ADDENDUM NO. 2

To the Drawings and Project Manual dated 16 June 2017

**TAS/ADA FIRE MARSHAL
DEFERRED MAINTENANCE PROJECTS
MIDWESTERN STATE
UNIVERSITY**

SCALE: 3"=1'-0"

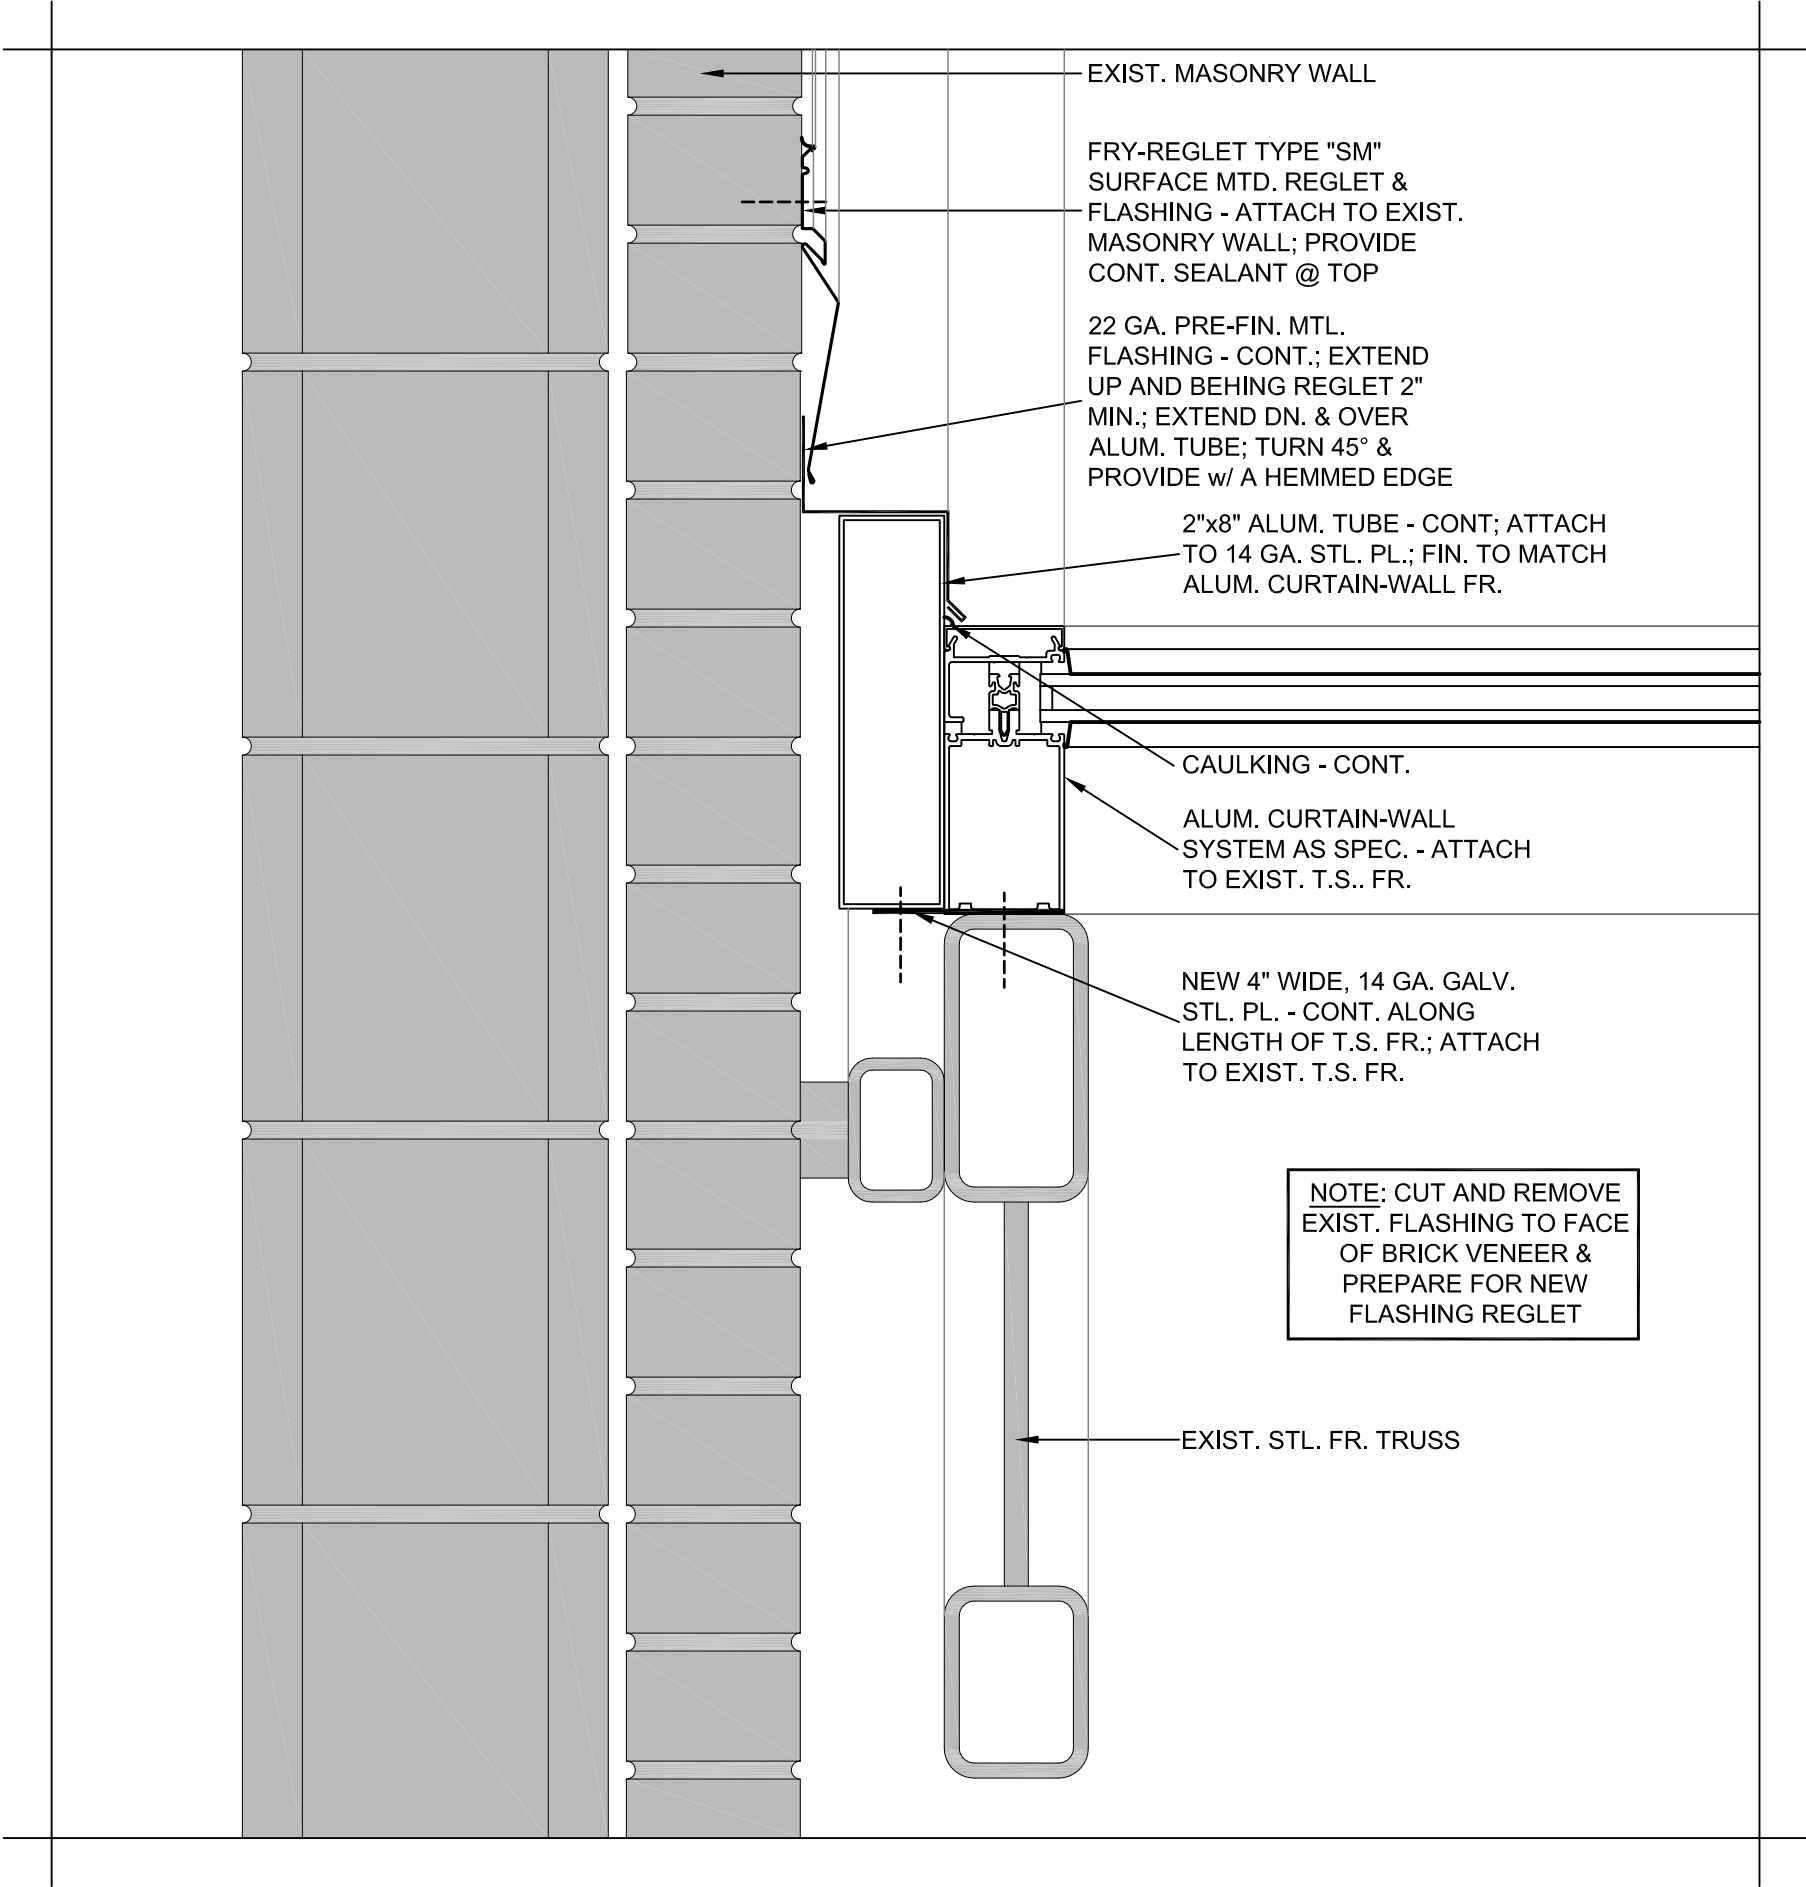
ADD: An **Alternate #3** which shall be all work associated with the removal of the existing sloped glazing system (existing steel tube joists and steel tube/pipe framing are to remain in place) and the provision of the new sloped glazing system (Opening **#FF21**) as indicated.

DELETE: On Sheet “**A502**”, the opening details “**A502-18**” as indicated.

ADD: Opening details “**A502-18**” as indicated on Supplemental Drawings “**AD#2-01**” through “**AD#2-05**” attached with this Addendum.

**BOLIN SCIENCE HALL - FIRST FLOOR - AREA 1C
ELECTRICAL DEMOLITION PLAN**

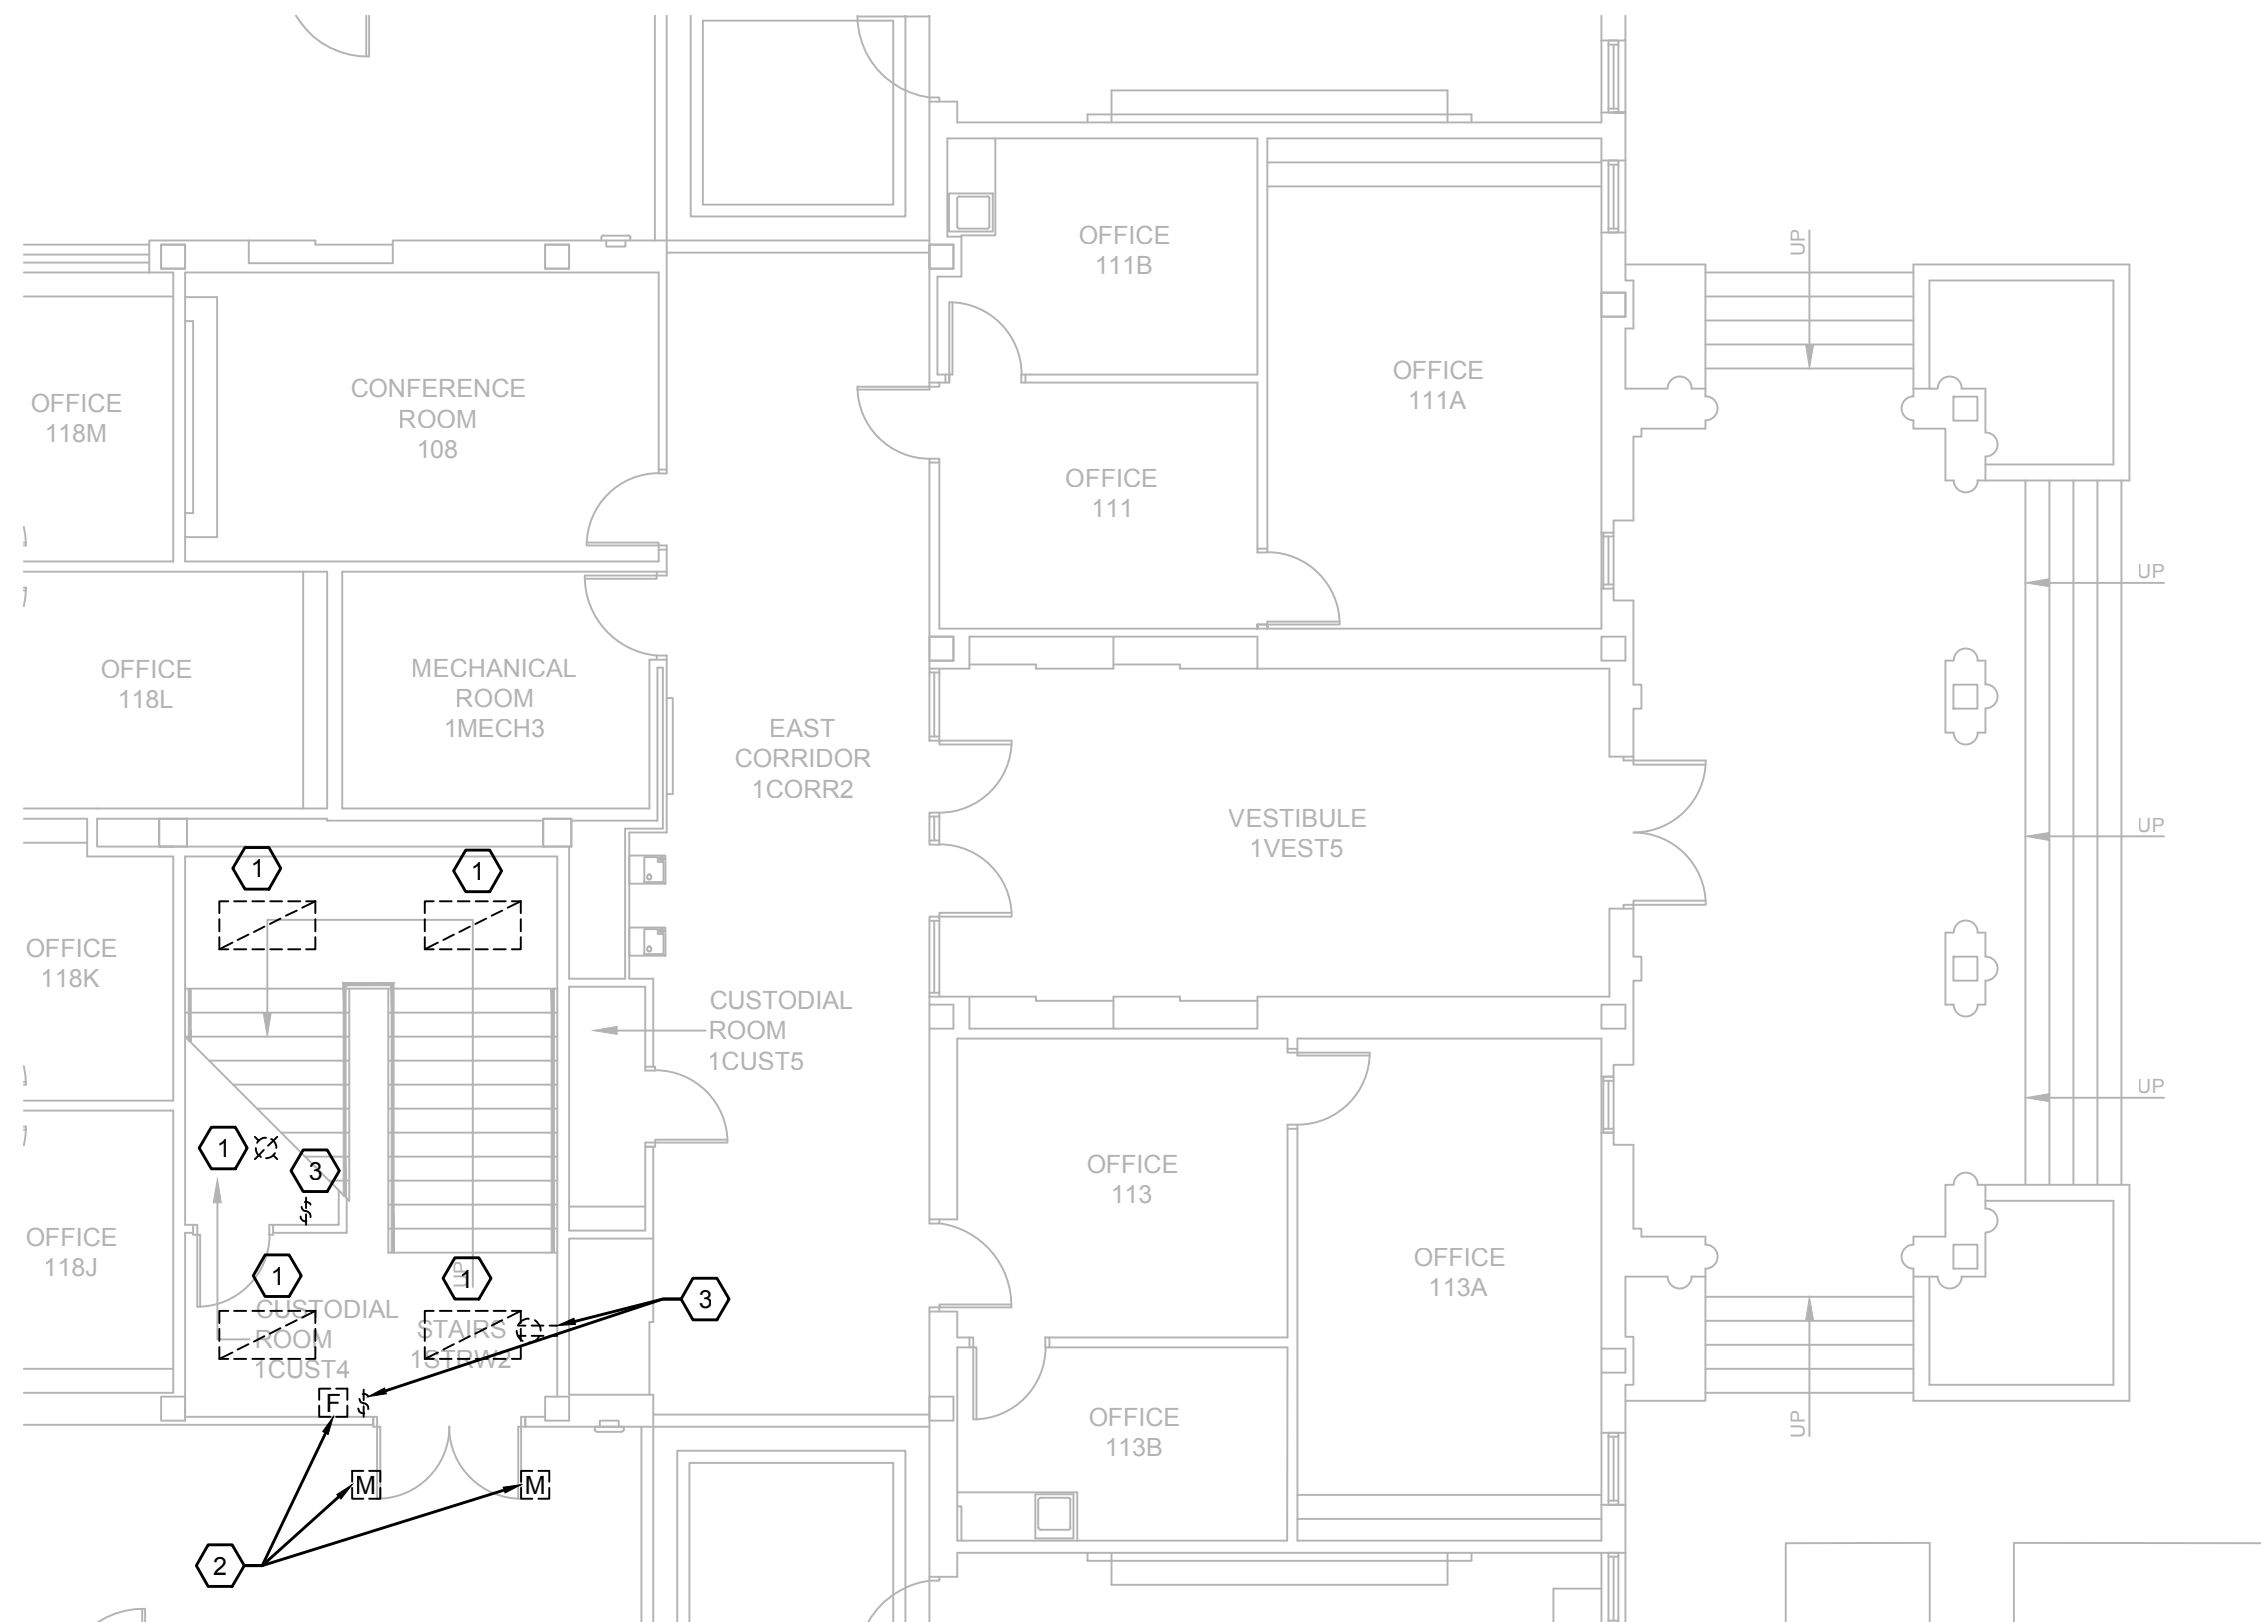
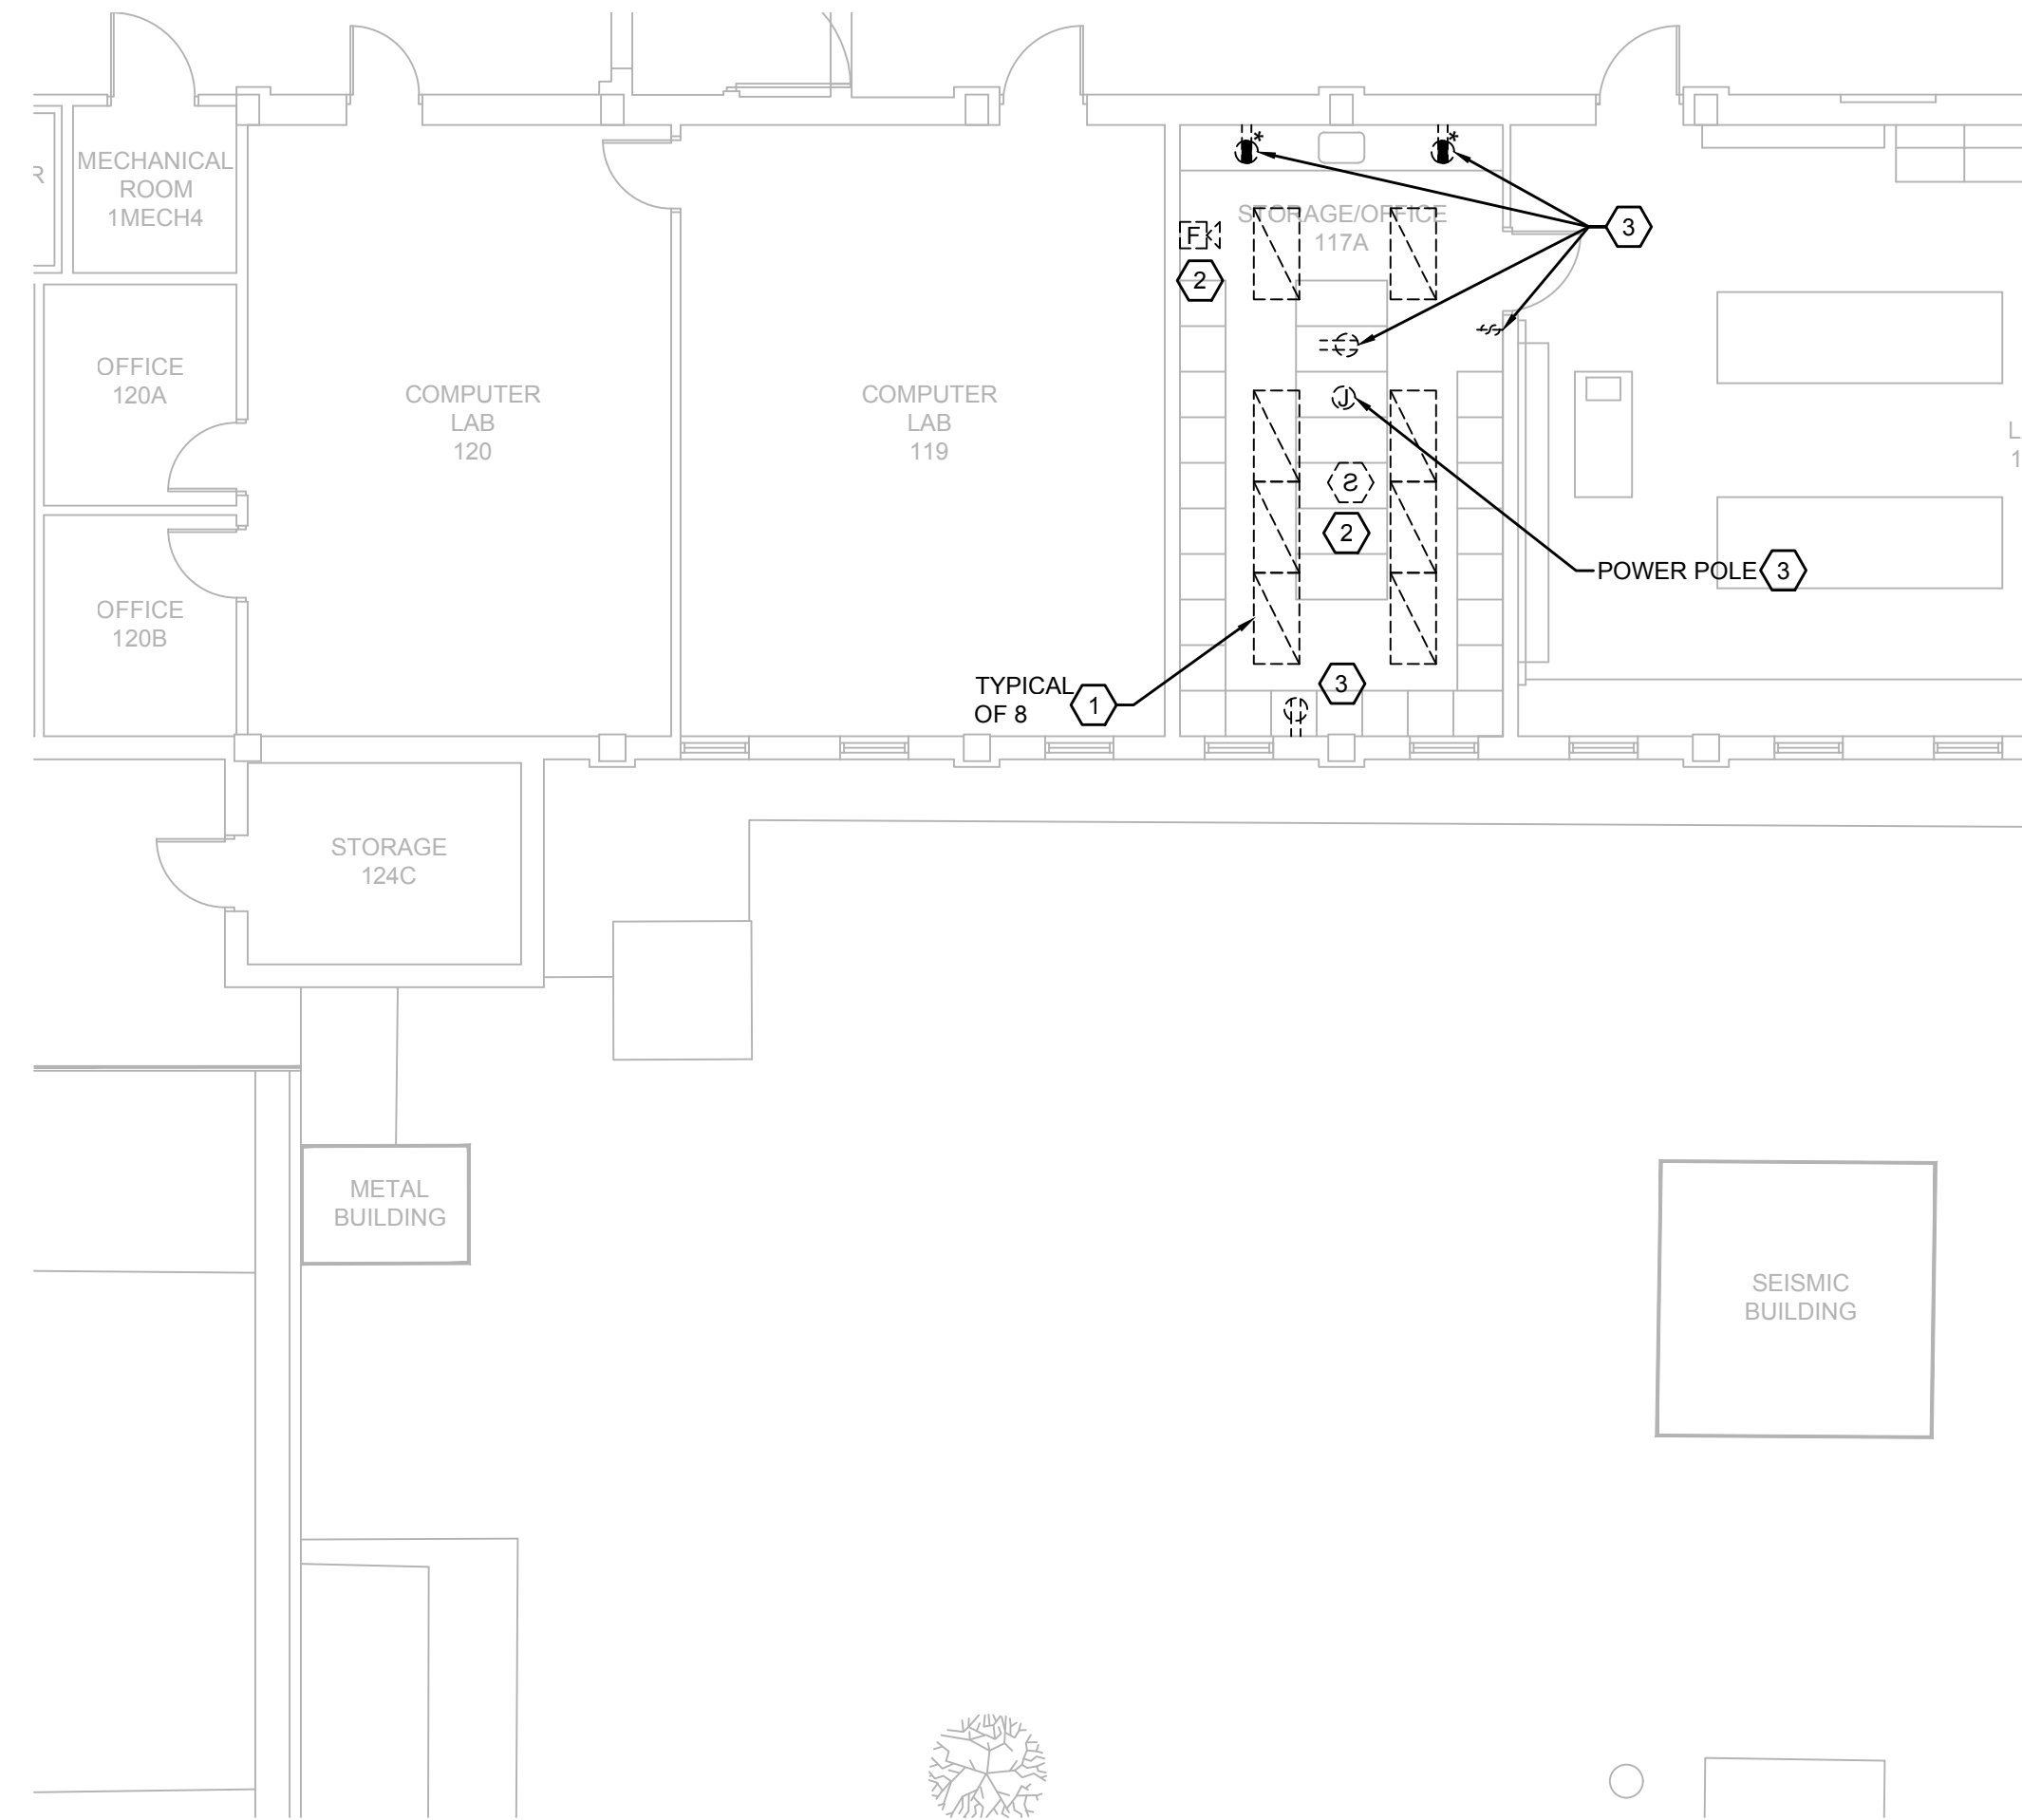
1. Sheet B-ED101 – Revised Drawing as follows:
 - a. Added Computer Lab room 133 lighting to be remove and stored as stated in Key Note #4.
2. Sheet B-E101 – Revised Drawing as follows:

4. REMOVE ALL LIGHTS IN THIS AREA AND STORE THEM DURING CONSTRUCTION FOR RE-INSTALLATION AFTER THE SPRINKLER PIPING HAS BEEN INSTALLED.
5. REMOVE EXISTING 2000KVA TRANSFORMER. APPLY ALL NECESSARY PRECAUTION TO PRESERVE THE PRIMARY DUCTBANK SERVING TRANSFORMER IN GOOD AND SAFE CONDITION. TIMING OF REMOVAL AND THE INSTALLATION OF THE NEW TRANSFORMER SHALL BE COORDINATED WITH OWNER TO MINIMIZE POWER DISRUPTION TO THE BUILDING. REF. DRAWING B-101. DISPOSE OF THE EXISTING TRANSFORMER IN COMPLIANCE WITH LOCAL, STATE, AND FEDERAL REGULATIONS. OWNER WILL PROVIDE TEST REPORT SHOWING TRANSFORMER DOES NOT CONTAIN PCB PRIOR TO REMOVAL.
